Access Compliance Report Public Rights-of-Way (Curb Ramps)

Main Street: MAIN_ST Cross Street: SECOND_ST Location: SW

ADA ID: RPRK211026175404 Ramp Type: Type 4 - Parallel Initial Pass/Fail: Fail Overall Compliance: No Severity Score: 2

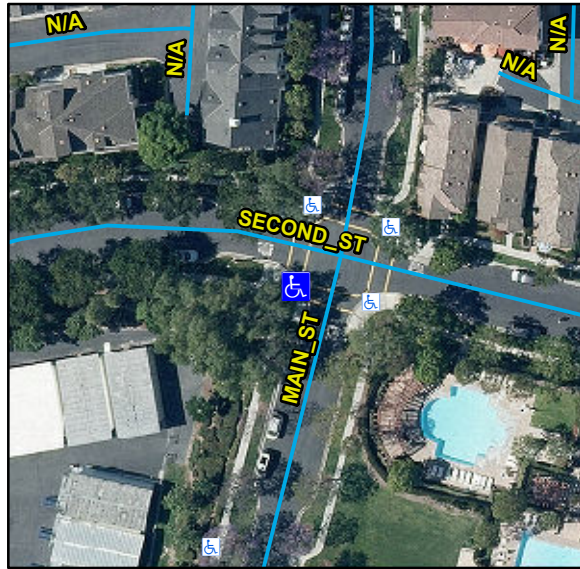
Compliance	Description	Data	Compliance	Description	Data
N/A	Ramp Length LT (in)	102	N/A	Ramp Length RT (in)	104
Yes	Ramp Width LT (in)	90	Yes	Ramp Width RT (in)	90
Yes	Ramp Run Slope LT (%)	2.6	Yes	Ramp Run Slope RT (%)	3.1
Yes	Ramp Cross Slope LT (%)	1.9	No	Ramp Cross Slope RT (%)	2.2
N/A	Landing Present	N/A	N/A	DWS Provided	N/A
N/A	Landing Length (in)	N/A	N/A	DWS Contrast	N/A
N/A	Landing Width (in)	N/A	N/A	DWS Length (in)	N/A
N/A	Landing Run Slope (%)	N/A	N/A	DWS Full Width	N/A
N/A	Landing Cross Slope (%)	N/A		DWS Offset Type	N/A
N/A	Landing Movement Obstructed?	N/A	N/A	DWS Offset Left (in)	N/A
	Landing Movement Type	N/A	N/A	DWS Offset Right (in)	N/A
N/A	Landing Shared	N/A			
N/A	Clear Space	Yes			
N/A	Clear Space To Crosswalk (in)	N/A			
N/A	Marked Crosswalk 1	No	N/A	Marked Crosswalk 2	No
	Crossing 1 Direction	SE		Crossing 2 Direction	NE
	Marked Crosswalk 1 Width (in)	N/A		Marked Crosswalk 2 Width (in)	N/A

Remove & Replace Curb Ramp With Two New Directional Ramps or Equivalent.
